CHANGE ORDER APPROVAL FORM

PROJECT: CR121 Pond Reconstruction CHANGE ORDER NUMBER: 02

CONTRACT NUMBER: CM1653

Reason for Change Order: Pond reconfiguration to control erosion and maintain existing drainage flows.

AS-BUILT

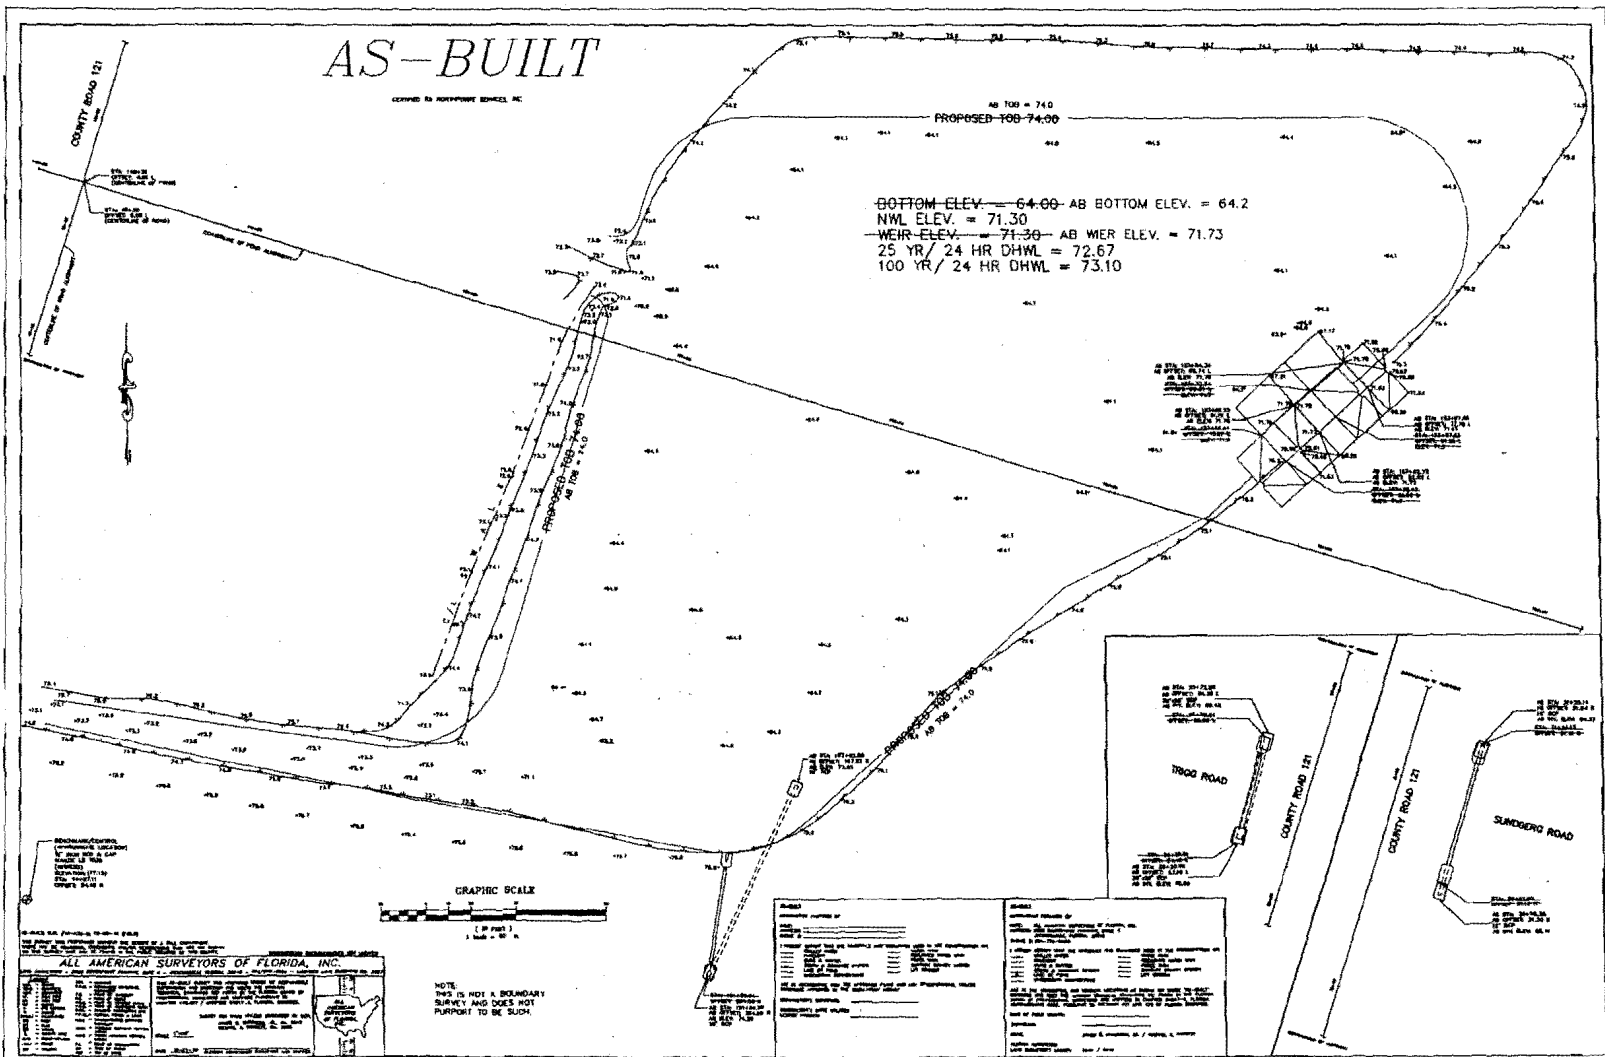
Reason for Change Order: Pond reconfiguration to control erosion and maintain existing drainage flows.

- 104-13-1 --> Did not utilize all of bid quantity.
120-1A --> Overrun necessary due to pond reconfiguration and necessity to maintain original drainage patterns.
530-3-4 --> Overrun necessary due to plan quantity error and addition of RipRap at MES treatment to eliminate erosion potentials.
570-1-2, Sod -> Overrun necessary due to pond reconfiguration and necessity to stabilize pond banks.
570-1-2 S&M -> Overrun necessary due to pond reconfiguration and necessity to stabilize pond banks.
ProPex --> Overrun necessary due to pond reconfiguration and necessity to stabilize pond banks.
Re-Mobe --> Addition necessary due to RipRap plan quantity error.
